**ACP-2020-24**

**E-7 WEDGETAIL OPERATING AREAS**

**GATEWAY DOCUMENTATION:  
STAGE 2 DEVELOP & ASSESS**

**STEP 2A AIRSPACE CHANGE DESIGN OPTIONS  
AND  
DESIGN PRINCIPLE EVALUATION**

**Figure 6. A1-A2 Outer Hebrides**

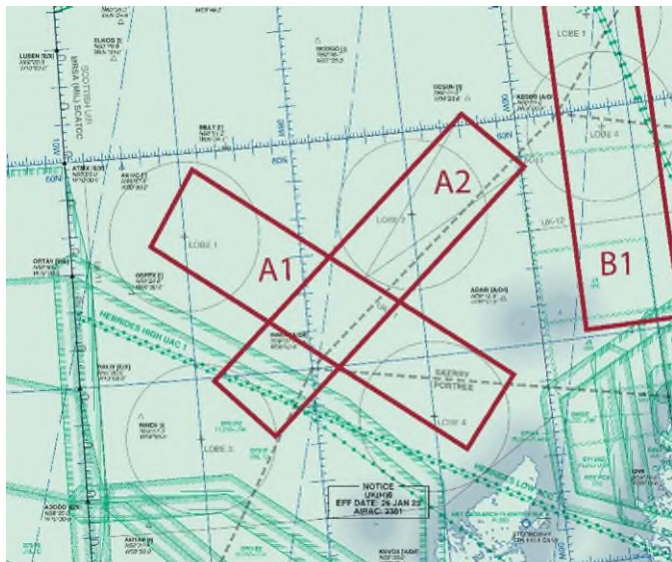
**Outer Hebrides (FL270-350)**  
 Within AEW UK 11  
 Limited impact on high level air routes and FRA

**Figure 7. B1-B4 Outer Hebrides**

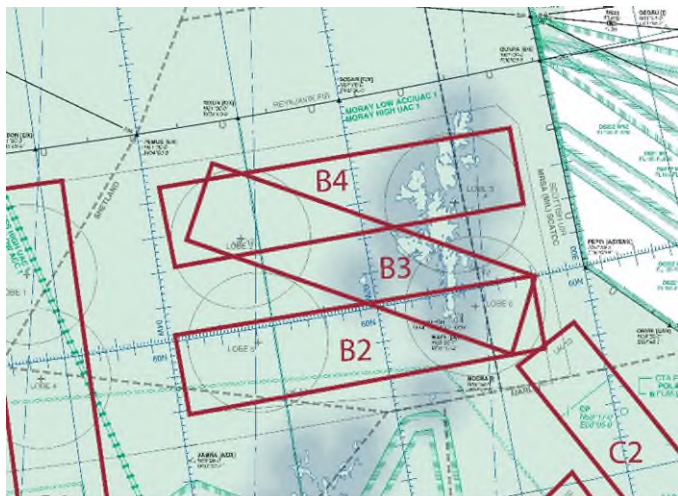
**North Capes/Shetlands (FL270-350)**  
 B2-4 within bounds of AEW UK 12. Area B1 extends south towards D712.  
 Limited impact on high level air routes and FRA  
 Coord with Swanwick Mil regarding concurrent activation with D712.

**Figure 8. C1-C2 Moray Firth**

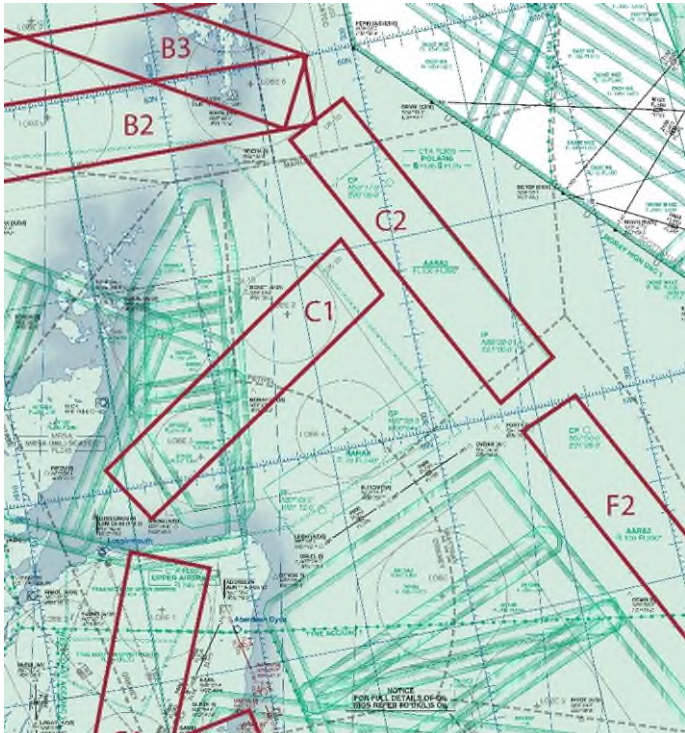
C2 new area to E of UK 10. Overlap with AARA2 (FL100-290) – coordination via Swanwick Mil or pre-flight planning.

Limited impact on high level air routes and FRA.

**Figure 9. D1 and E1-E2 East Coast**

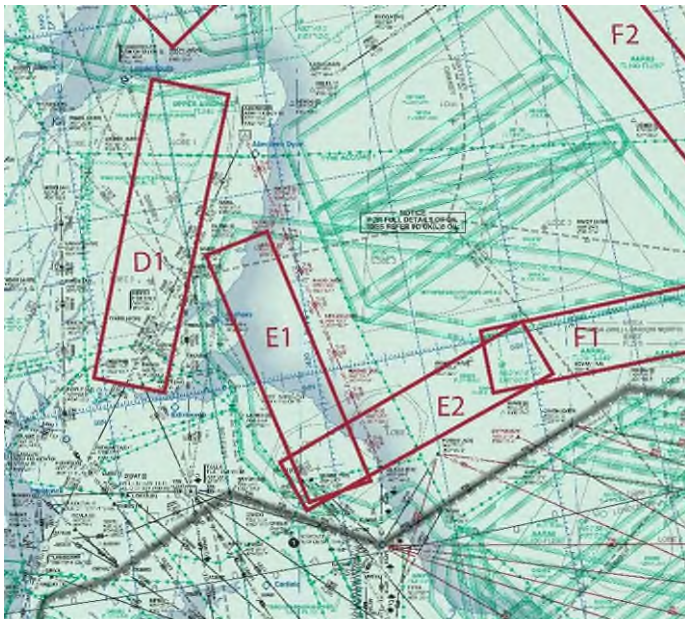
E1 IVO Edinburgh and Newcastle Aerodromes. No effect on SIDS/STARS due to altitude.

E2 IVO Newcastle Aerodrome only. No effect on SIDS/STARS due to altitude. Located above AARA5 (FL070-240) and between D323 and D613 series danger areas, coordination will be managed through Swanwick Mil/ASACS.

**Figure 10. North Sea**

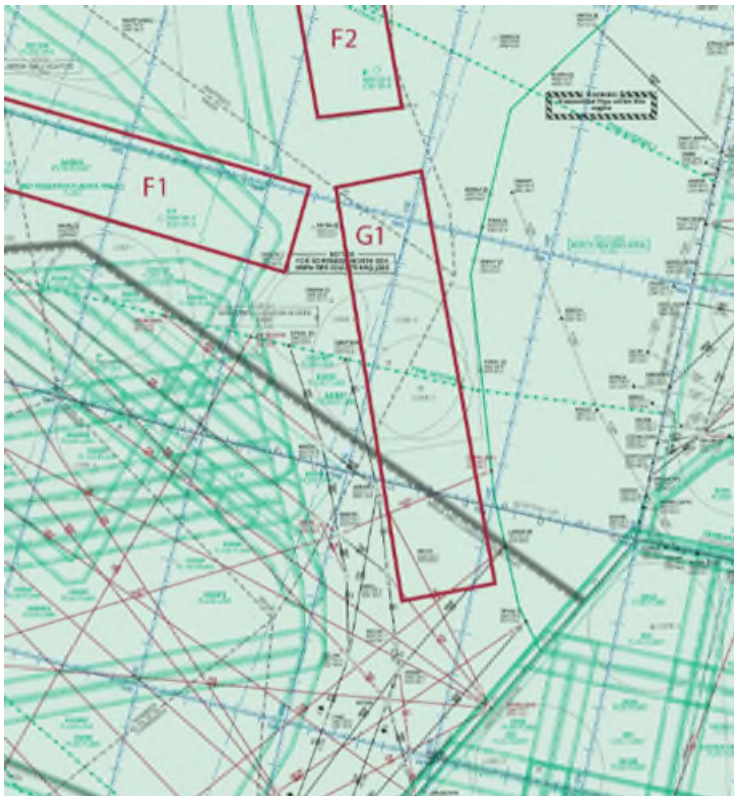
Located E of D323 danger area complex IVO AEW UK6. SE corner is approx. 20nm of UK UIR boundary. Notification of area activation will ensure adjacent ATC are aware.

Upper airways routing N-S when D323 complex activated but traffic likely to be above E-7 operating level.

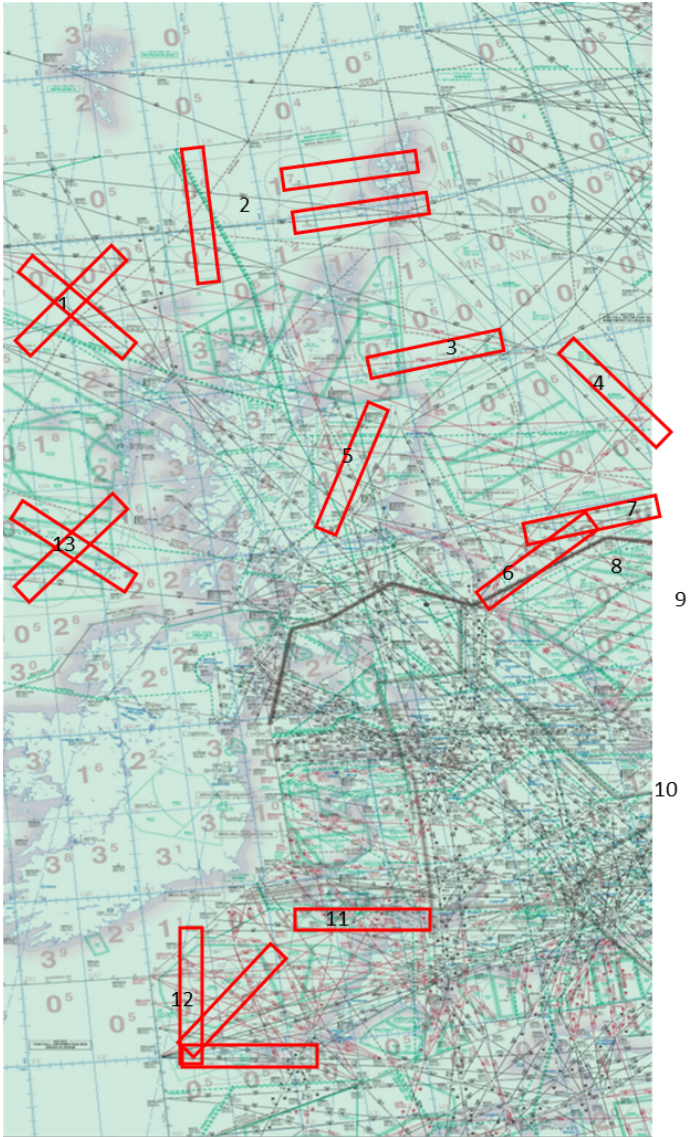
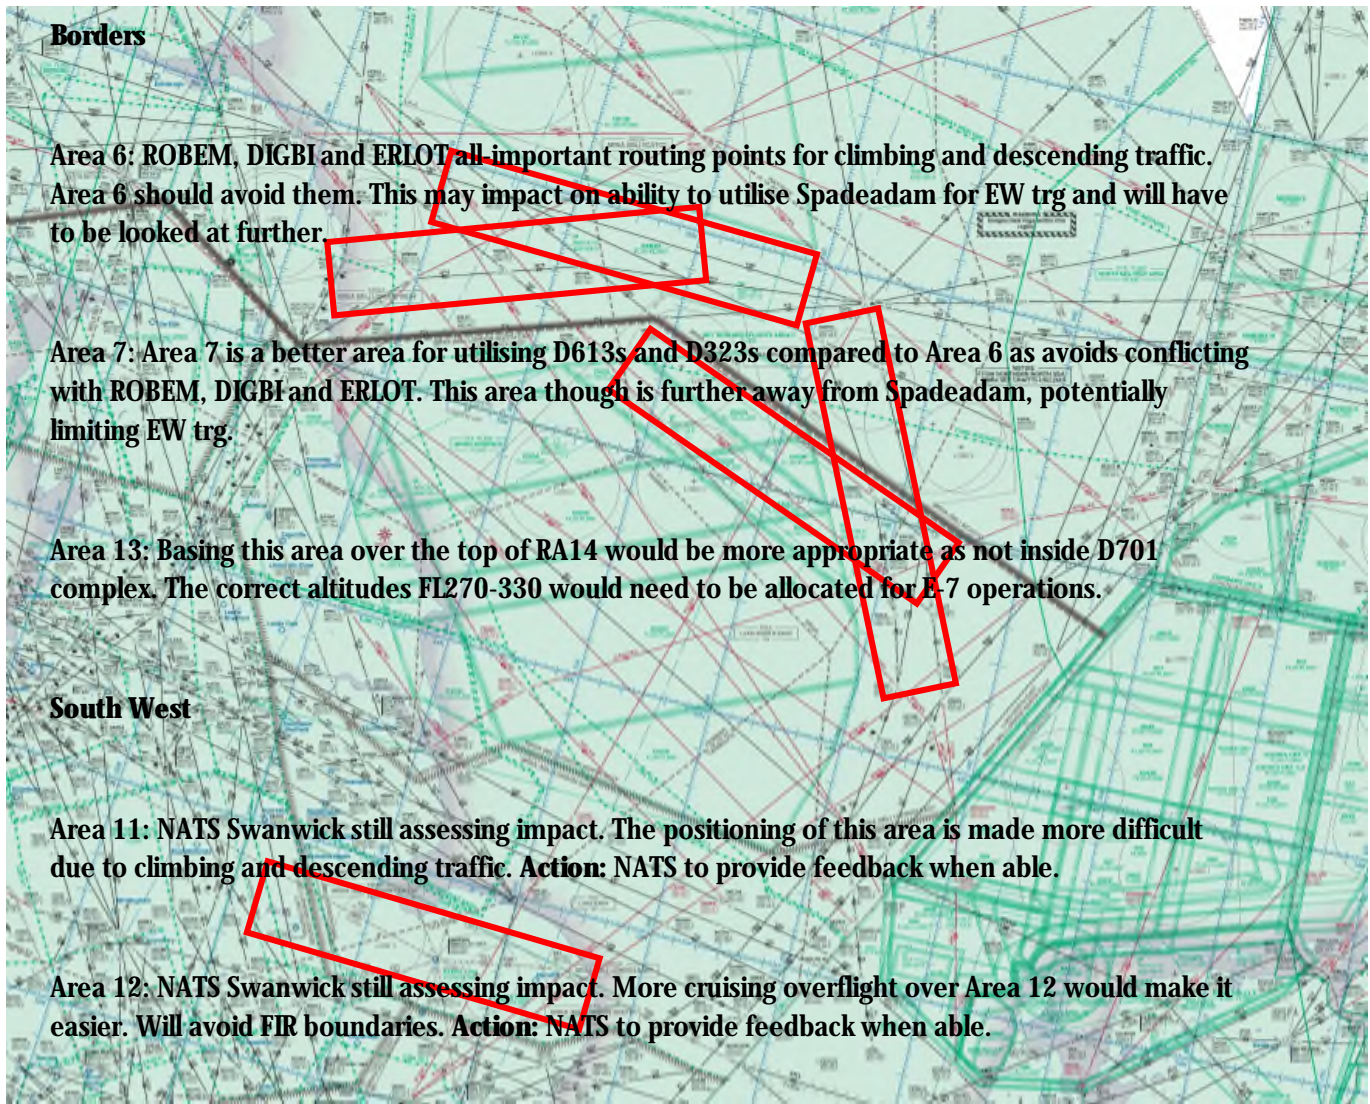
**Area 3: Intrudes slightly into D809. Using RA4 would conflict with climbers and descenders out of Aberdeen. Could Area 3 be moved further East to overlap RA2 and thus avoid confliction with D809?**

**Area 4: Area 4 is above RA3. The area could go above RA3. Further discussion required about deconflicting tanker activity from orbit area use and how either area would be activated / operated concurrently.**

**Area 5: This area could conflict with traffic pushed East by TDA597. Likely if TDA597 was active then E-7 would be operating inside it as part of the Ex (Already discussed with the MOD sponsor of TDA597). RA1 is in close vicinity of Area 5, the potential to establish an area above RA1 for E-7 operations was discussed. This plan would be depend on radar look into D613 from that location.**
